Subject: Sequoyah Fuels Corporation, Docket – 40-8027
Response to Draft Safety Evaluation Report – Reclamation Plan
(TAC L52511)

ENCLOSURE 1
Reclamation Plan
Draft Safety Evaluation Report
Response to Open Issues and Confirmatory Items

Sequoyah Fuels Corporation Draft Safety Evaluation Report Open Issues and Confirmatory Items

FIGURE 24 PROPOSED ADDITIONAL DETECTION MONITORING WELL

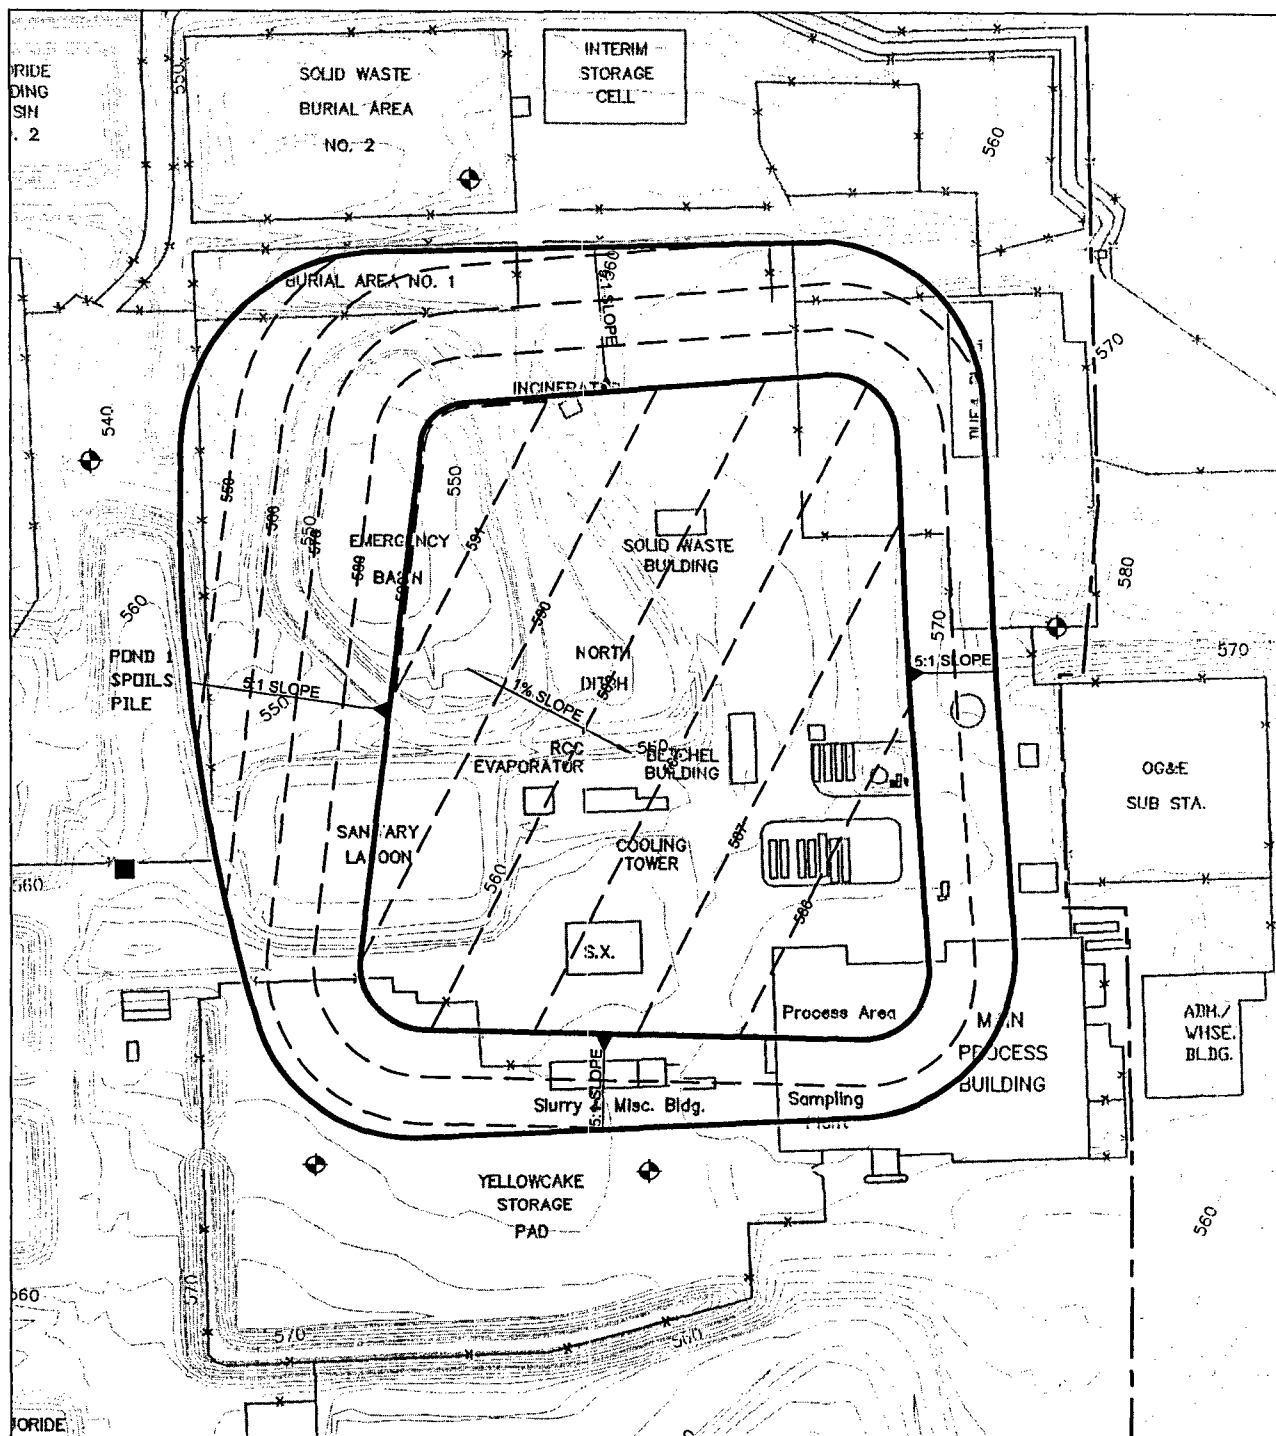
Detection monitoring wells were proposed to the north west and south west of the cell as this is the general direction for most of the historic groundwater movement in the area. However, it is recognized that cleanup activity could alter future groundwater directions in the immediate vicinity of the disposal cell. For this reason an additional well has been incorporated into the monitoring system along the west side of the cell as shown on Figure 24 enclosed with this response, and incorporated on Drawing 13 of the Technical Specifications.
